**Amendments to the Drawings:**

Application No. 10/761,458  
Response to Office Action

FIG. 6

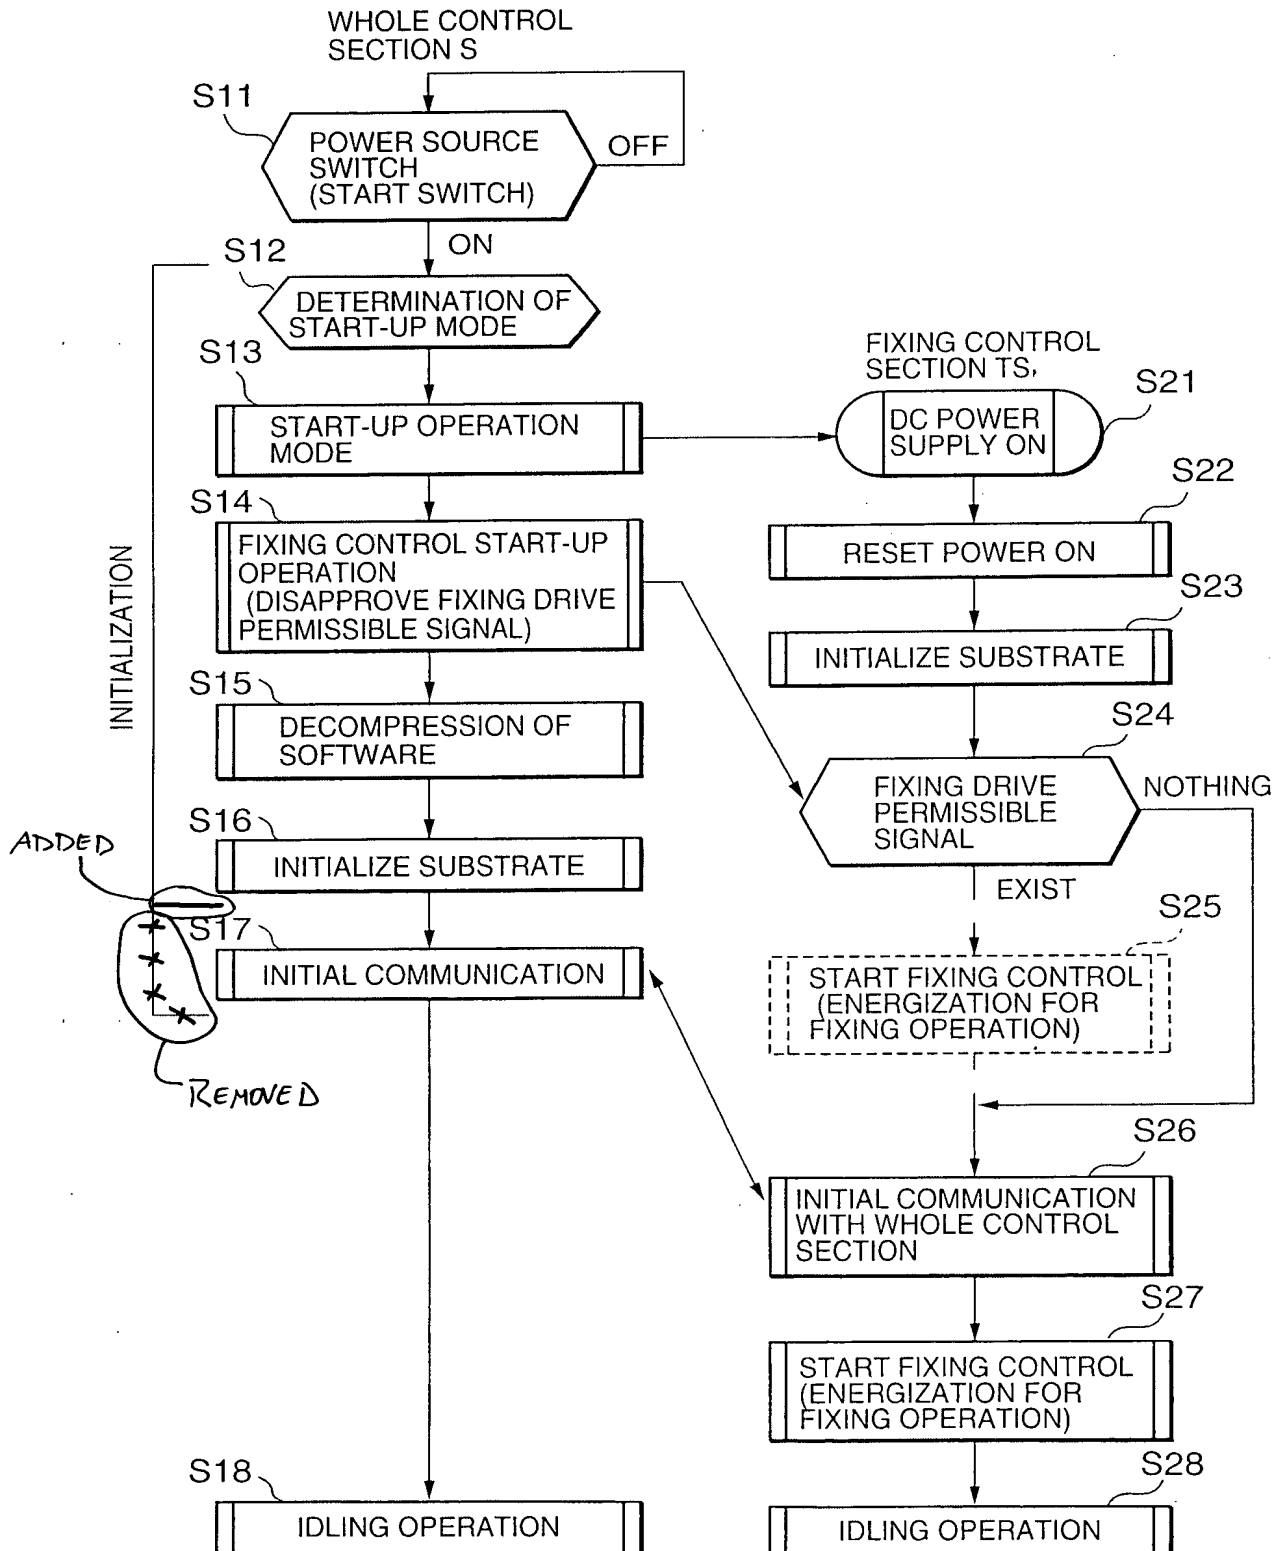
Figs. 6 and 7 have been amended to clarify that only steps S12-S16 (not step S17) are included in the "initialization," in accordance with the disclosure in the specification at page 22, lines 5 and 6.
